CITY OF PORTLAND, MAINE

Project Name: Master Development Plan for 383 Commercial Street (former Rufus Deering site)
Project ID: #2017-005
Address: 383 Commercial Street CBL: 042 A001001
Applicant: Deering Property Development, LLC (Joe Dasco)
Planner: Jean Fraser

PLANNING BOARD REPORT PORTLAND, MAINE

383 Commercial Street (former Rufus Deering Site)
Level III Master Development Plan
Deering Property Development, LLC, Applicant
Project #: 2017-005
CBL: 042 A001001

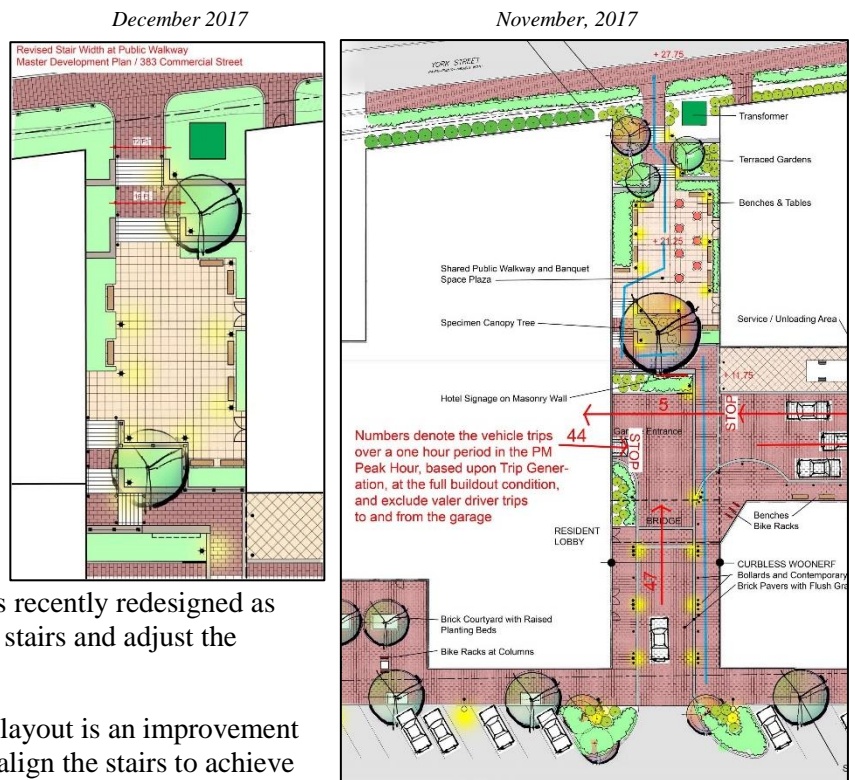
The design and layout of the public passageway area has been the subject of staff comments regarding the October layout (right) requesting that the path be more direct and wider so that people would be able to see the destination and that they can get through to the other street and to ensure it does not create “dark corners”.

Staff also consider that the Woonerf part of the passageway could include more to create a pedestrian-friendly plaza area and separate it from the service area.

The northern part of the passageway was recently redesigned as shown in the smaller plan to widen the stairs and adjust the planting (Plan P31).

Staff have commented that this revised layout is an improvement but that further revisions are needed to align the stairs to achieve visual connectivity (Attachments 1 and 5).

Staff recommend a condition that highlights the objectives of usable public space and visual continuity to provide a framework for revisions at the site plan stage.

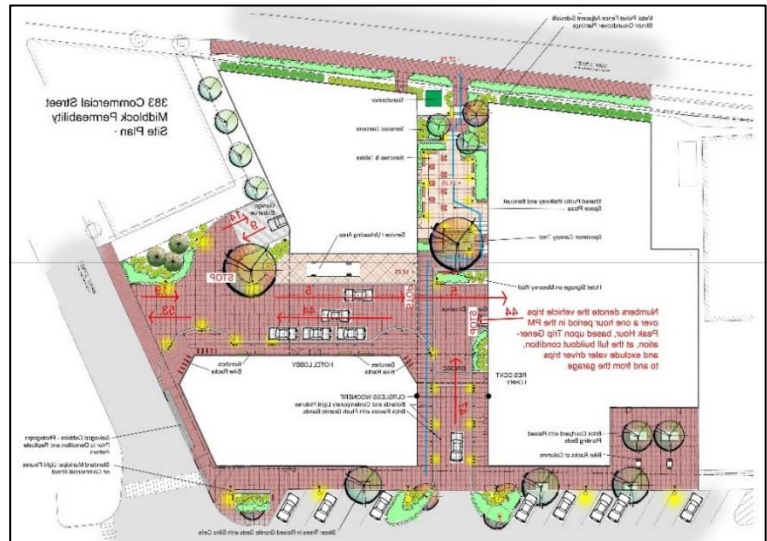
Prior to the construction of Phase 3, the hotel parking supply is proposed to be partially met through the provision of 47 spaces in a surface lot at the west end of the site. The applicant has noted that surface parking is a permitted use, but the scale of parking is a Planning Board determination. The parking allocation note in Attachment G confirms that the parking for hotel guests will be mandatory valet-only and the potential layout is shown in Plan P29. It is understood that this area of surface parking is accessible both from the lower level of the garage and from Commercial Street via the existing access that will also serve the construction offices and staging area located in the original Rufus Deering building.

At the November Workshop the City's Waterfront Coordinator Bill Needelman noted (Attachment 4) that the waterfront (marine) employees currently use some of the on-street parking along the frontage of the Rufus Deering site and that the loss of local parking is a pressure on the marine business. The applicant has offered to provide some parking for the benefit of the marine/waterfront economy within this interim parking lot. Staff consider that parking in the interim condition appears to address some identified needs, and that the area could be subject to a phased combination of parking and landscaping/buffer treatment until the last phase of the MDP is implemented.

It is understood that the on-street parking along the frontage would likely be metered public parking.
